# Access Compliance Report

### (Curb Ramps)

Intersection ID: 47911	Main Street: ROOK_RD	Cross Street: RINGNECK_RD	Location: NE
ADA ID: 815FC05D6C72	Ramp Type: PerpDiag	Initial Pass/Fail: Fail	Overall Compliance: No
Codes/Mitigation Info/Possible Solution		Field Measurements/Component Compliance	
Severity Score: 46.25

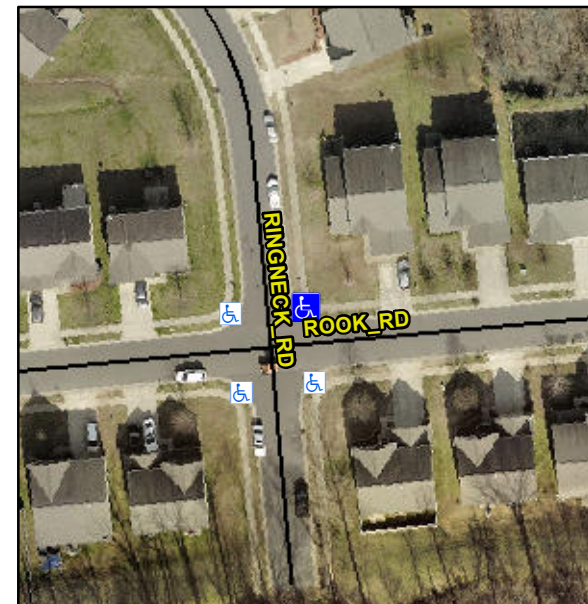
**Not Found, R304.5.1, R304.2.2, R304.5.3**

Compliance	Description	Data	Compliance	Description	Data
N/A	Ramp Length (in)	44.5	No	Ramp Slope (%)	8.7
No	Ramp Width (in)	47.5	No	Ramp XSlope (%)	8.0
N/A	Flare Type LT	N/A	N/A	Flare Type RT	N/A
N/A	Flare Slope LT (%)	N/A	N/A	Flare Slope RT (%)	N/A
N/A	Flare Traversable LT?	N/A	N/A	Flare Traversable RT?	N/A
N/A	Landing Length (in)	N/A	N/A	DWS Provided?	N/A
N/A	Landing Width (in)	N/A	N/A	DWS Contrast?	N/A
N/A	Landing Slope (%)	N/A	N/A	DWS Length (in)	N/A
N/A	Landing X Slope (%)	N/A	N/A	DWS Full Width?	N/A
N/A	Landing Curb? (Y/N)	N/A	N/A	DWS Offset (in)	N/A
N/A	Shared Landing?	N/A			
N/A	Gutter Ponding?	N/A	N/A	Gutter Slope (%)	N/A
N/A	Gutter Lip Ht (in)	N/A	N/A	Gutter X Slope (%)	N/A
N/A	Painted X Walk1?	No	N/A	Painted X Walk2?	No
	X Walk 1 Direction	To W		X Walk 2 Direction	To S
N/A	X Walk 1 Width (in)	N/A	N/A	X Walk 2 Width (in)	N/A
	X Walk 1 Slope (%)	2.2		X Walk 2 Slope (%)	6.2
	X Walk 1 X Slope (%)	4.4		X Walk 2 X Slope (%)	3.4

**Remove & Replace Curb Ramp With Two New Directional Ramps or Equivalent.**
